## DESIGN REVIEW APPLICATION

Address of Proposed Work: 336 Moreland Way

**DEPARTMENT OF PLANNING AND ZONING  
PLANNER'S REPORT**

DATE: August 12, 2019  
TO: Tonya Hutson  
FROM: Lynn Patterson  
RE: **Design Review – 336 Moreland Way**

PROPOSED  
FLOOR PLAN

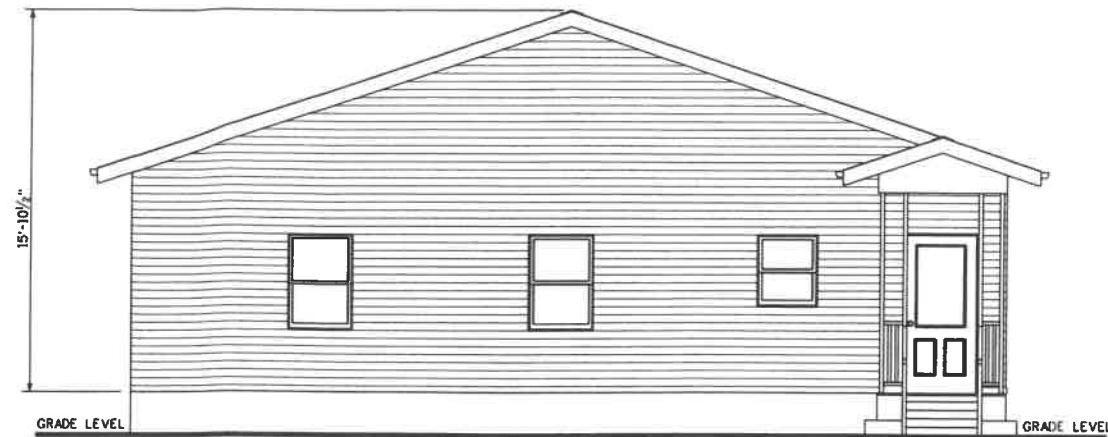
- The plans indicate the new construction will use/replace existing windows without altering placement. However, the provided pictures of the existing house do not match the provided floorplan. Any new or completely rebuilt windows must comply with the requirements found in the *door and window standards* section.

ELEVATIONS

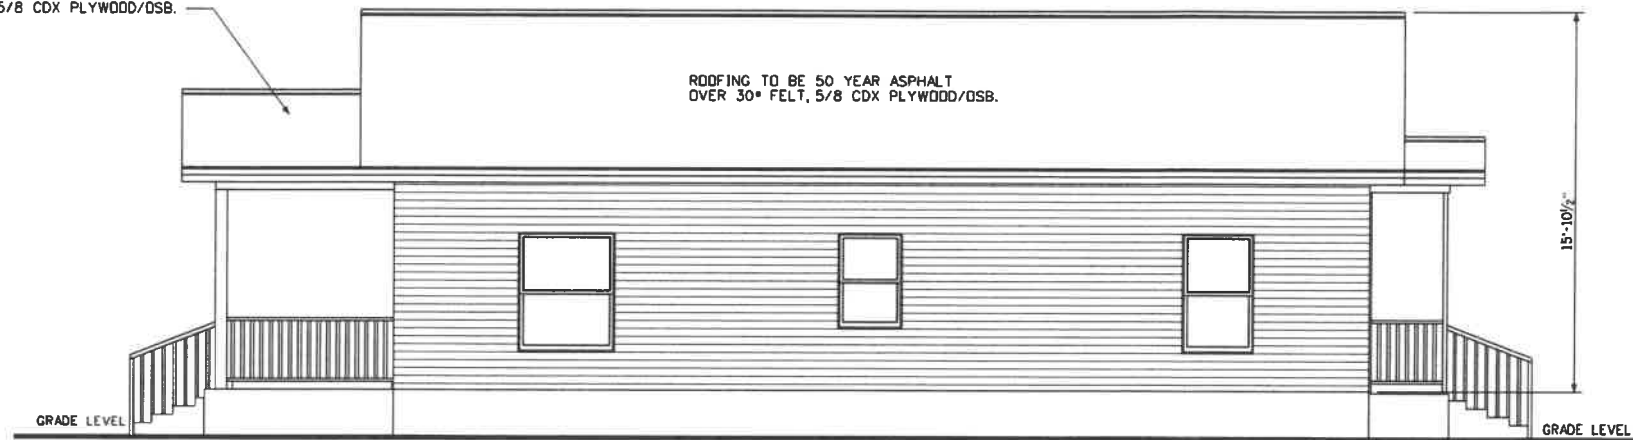
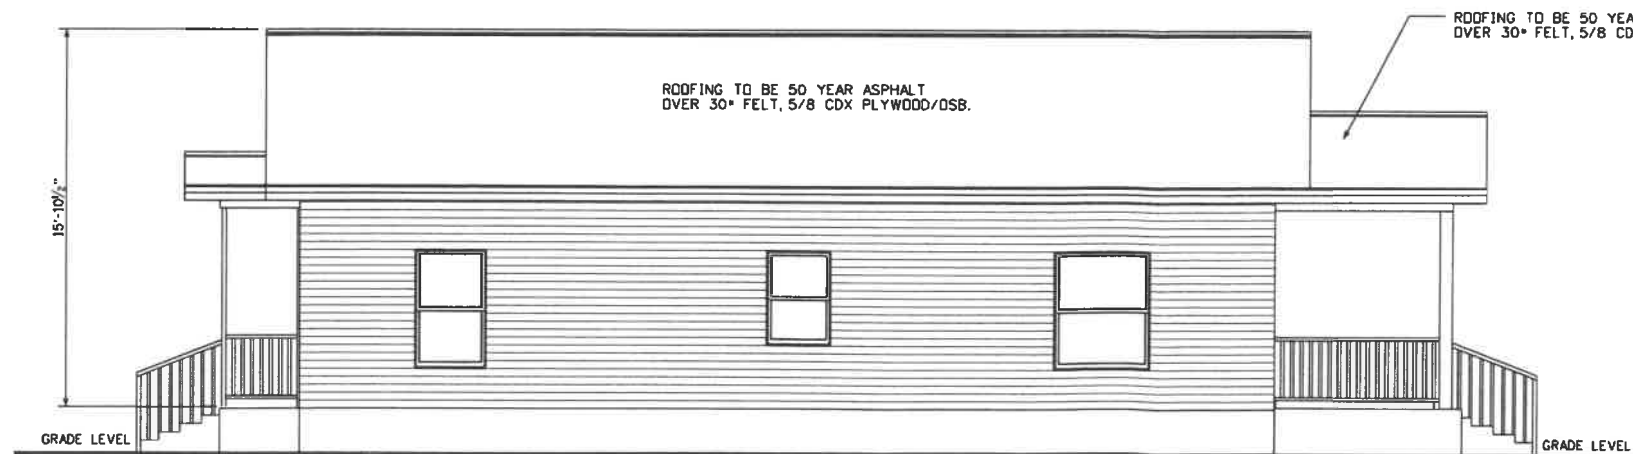
- Gutters and downspouts should be shown on plans.
- The applicant should provide the distance the new roof overhangs beyond the façade.

- Existing vinyl siding to be replaced with Hardie board.
- No dimensions or materials have been provided for the front porch.
- The extent to which the front façade will be impacted by development is unclear. The porch as shown in the plans does not conform to the existing porch. Any changes to the front porch must comply with the *Street Facing Façade and Style Standards*.

If the applicant is replacing the fire damaged walls and changing the roof form without any other changes, then the application can be approved once the applicant updates their plans to show gutters and downspouts. If the applicant is performing more work than is indicated, the application must be updated with required information related to all changes.

FRAMING & ROOF  
PLANS

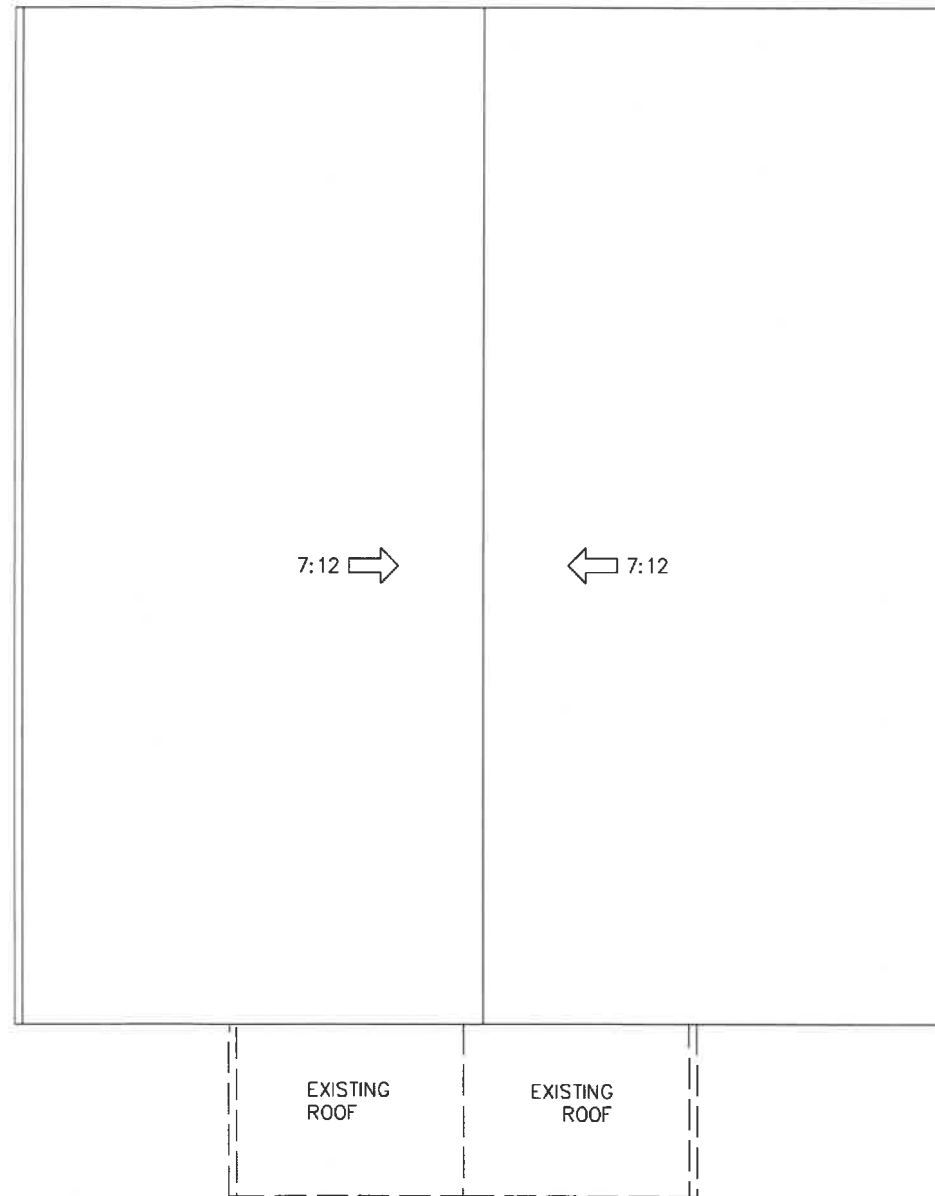
The scope of construction related to the restoration is unclear. The application indicates the only demolition taking place is within the interior. However, the photographs provided by the applicant indicate severe damage to the rear of the structure that will likely require more extensive work than merely replacing siding. Also, the windows shown in the provided photographs do not match those in either the existing or proposed floor plans. In addition, the roof shown on the plans has an entirely different form than the existing structure.
